2. COA-079808-2019

507 North 28th Street

Commission of Architectural Review

Remove a rear deck and construct a one-story screened porch.

Figure 3. View of the rear from the alley.

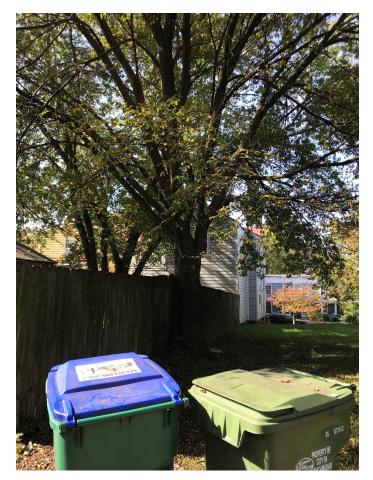
- The screening be placed on the interior of the posts and railing, to maintain the open appearance of the porch.
- An alternate material be used to clad the porch roof, specifications to be submitted to staff for administrative review.

New Construction, Decks, pg. 51 #1-5	 Decks should not alter, damage or destroy significant site elements of the property. Decks should complement the architectural features of the main structure without creating a false historical appearance. Decks should be painted or stained a neutral color that complements one or more of the colors found on the main structure. Deck design may include vertical picket balustrades or contemporary railing that is in scale with the house and the deck. Deck sub-decking should be screened with wood lattice work or with brick piers. As is the case with all other auxiliary structures, decks cannot be constructed in front yards (in accordance with the Zoning Ordinance). 	The <i>Guidelines</i> do not specifically address the construction of a one-story, screened-in porch. The proposed screened porch generally meets the guidelines for new construction and decks as it is located at the rear of the dwelling, is subordinate in size, and does not alter, damage or destroy significant site elements of the property. <u>Staff recommends the screening be placed on the interior of the posts and railing, to maintain the open appearance of the porch.</u>

Standards for New Construction Materials & Colors, pg. 53 #2	Materials used in new construction should be visually compatible with original materials used throughout the surrounding neighborhood.	The Guidelines state that asphalt shingles are not appropriate for historic structures and staff finds that it is not appropriate to use this material in the construction of the new porch roof. <u>Staff recommends an alternate material be</u> used to clad the porch roof, specifications to be
Maintenance and Repair, pg. 96	Asphalt shingles are made of felt impregnated with asphalt and covered with colored ceramic or stone granules. This modern roofing material is an inappropriate choice for the majority of historic structures.	submitted to staff for administrative review.
